PLANNING & ZONING BOARD - CITY OF WILDWOOD

Agenda

September 3, 2024 2:15 PM

City of Wildwood

SITE PLAN

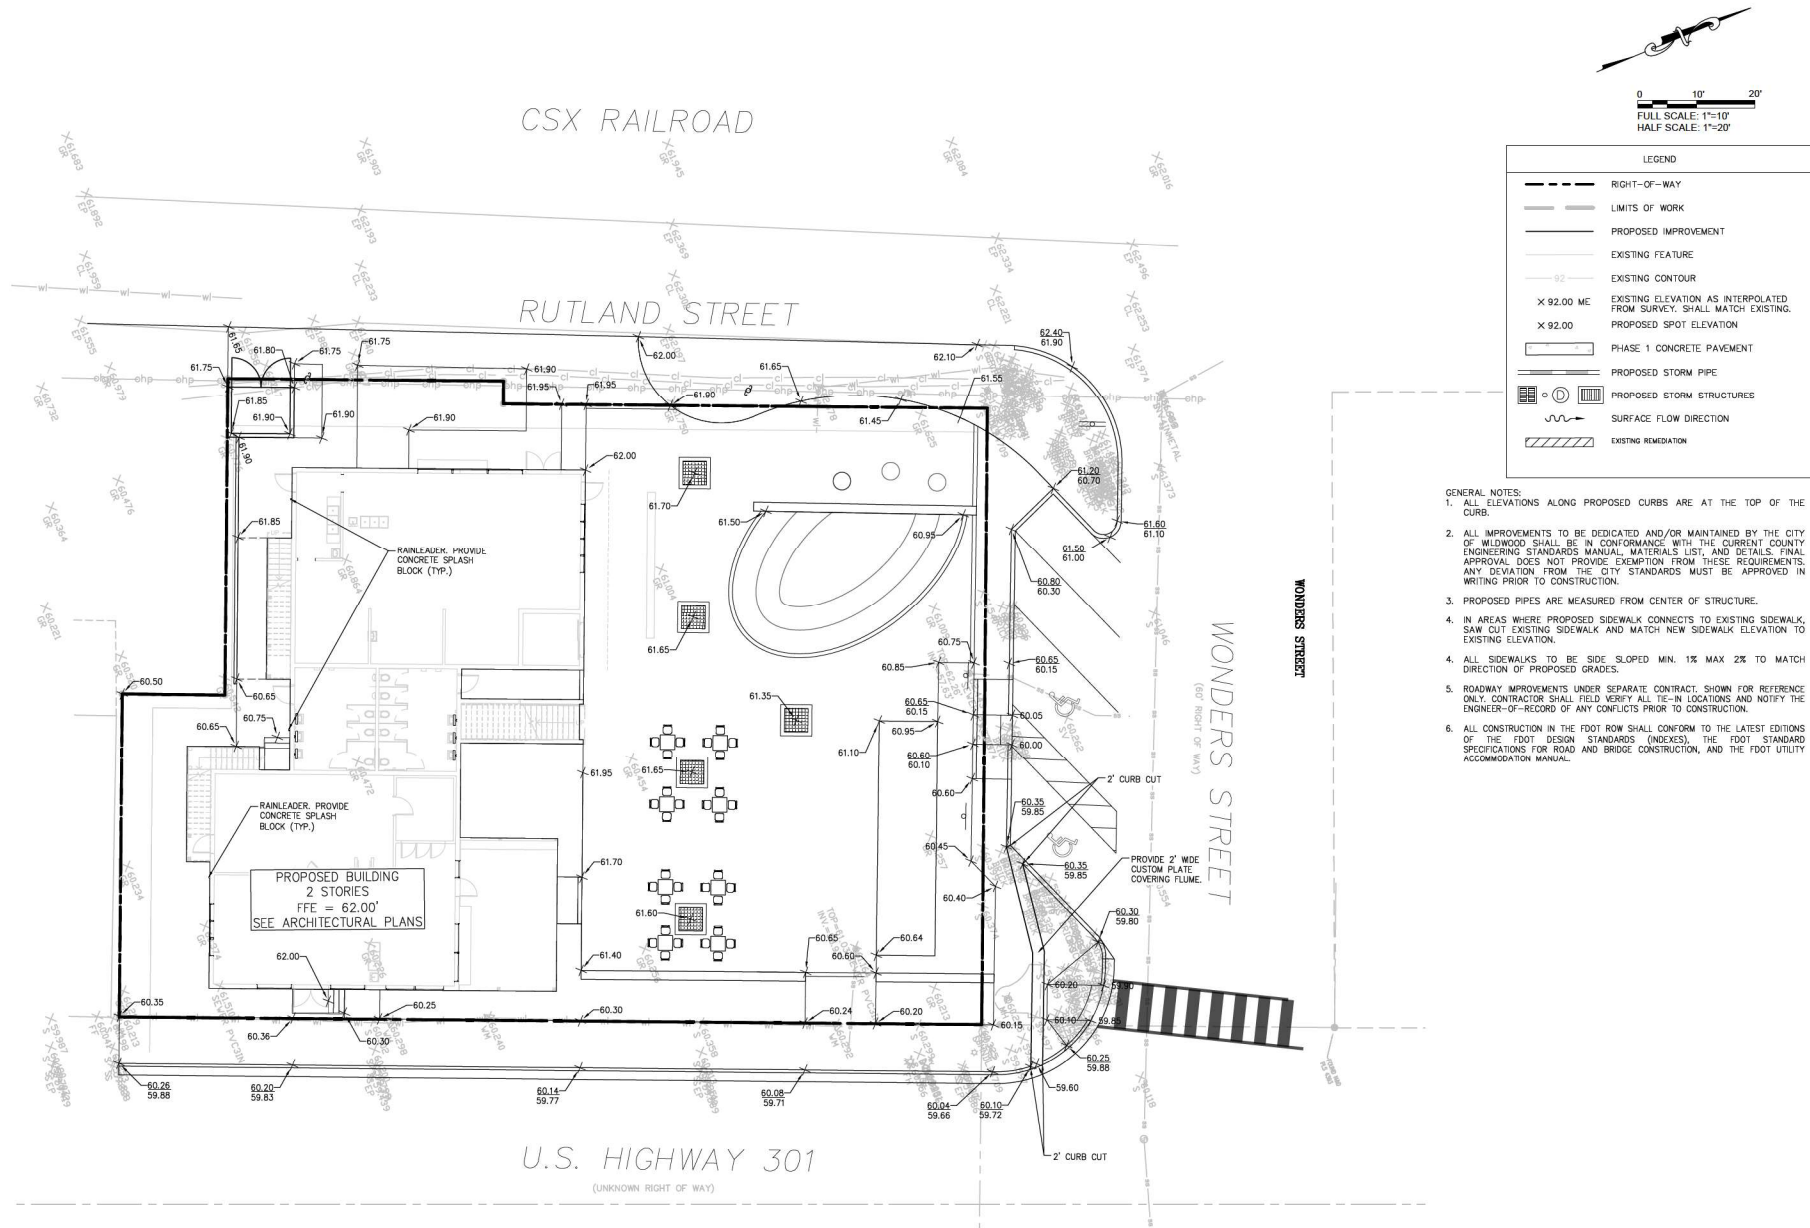
1. Provide construction type and fire flow per FFPC 1:Table 18.4.5.2.1. ***STILL MISSING. ***
2. Provide current hydrant flow test report (form attached) in compliance with FFPC 1:18.3.1, NFPA 291. ***MISSING PAGE 2 of 3. SUBMIT COMPLETE FORM. ***
3. Show fire sprinkler riser access door in compliance with FFPC 1:13.1.5. ***STILL MISSING. PROVIDE PLAN, ELEVATION, AND FLOORPLAN VIEWS. RISER ROOM MUST BE LIGHTED AND HEATED. (NFPA 13:8.3.1.8.2) ***
4. Provide automatic freeze protection for the fire backflow preventer. (NFPA 24:6.5.2) ***STILL MISSING***
